Access Compliance Report Public Rights-of-Way (Curb Ramps)

Intersection ID: 21964 Main Street: CAMBRIDGE_CRESCENT_DR Cross Street: SHEFFIELD_CRESCENT_CT Location:

ADA ID: 1B4ECAFD0AA9 Ramp Type: Perp Initial Pass/Fail: Fail **Overall Compliance: No** Severity Score: 21.25

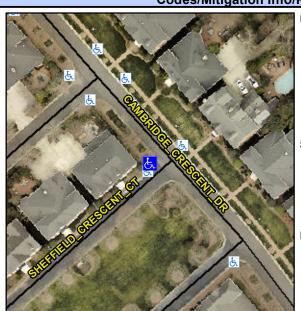
Possible Solutions: Remove & Replace Entire Ramp. Surveyor Notes: N/A PROW/ADA: Not Found, R304.5.1, R304.2.2

Field Measurements/Component Compliance						
Compl	liance Description	Data	Compl	iance	Description	Data
N/A	Ramp Length (in)	53.0	No	Ramp	Slope (%)	11.8
No	Ramp Width (in)	39.0	Yes	Ramp	xSlope (%)	1.6
N/A	Flare Type LT	N/A	N/A	Flare	Type RT	N/A
N/A	Flare Slope LT (%)	N/A	N/A	Flare	Slope RT (%)	N/A
N/A	Flare Traversable LT?	N/A	N/A	Flare	Traversable RT?	N/A
N/A	Landing Length (in)	N/A	N/A	DWS	Provided?	N/A
N/A	Landing Width (in)	N/A	N/A	DWS	Contrast?	N/A
N/A	Landing Slope (%)	N/A	N/A	DWS	Length (in)	N/A
N/A	Landing X Slope (%)	N/A	N/A	DWS	Full Width?	N/A
N/A	Landing Curb? (Y/N)	N/A	N/A	DWS	Offset (in)	N/A
N/A	Shared Landing?	N/A				
N/A	Gutter Ponding?	N/A	N/A	Gutte	er Slope (%)	N/A
N/A	Gutter Lip Ht (in)	1.0	N/A	Gutte	er X Slope (%)	N/A
N/A	Painted X Walk1?	No	N/A	Paint	ed X Walk2?	N/A
	X Walk 1 Direction	То Е		X Wa	lk 2 Direction	N/A
N/A	X Walk 1 Width (in)	N/A	N/A	X Wa	lk 2 Width (in)	N/A
	X Walk 1 Slope (%)	3.7		X Wa	lk 2 Slope (%)	N/A
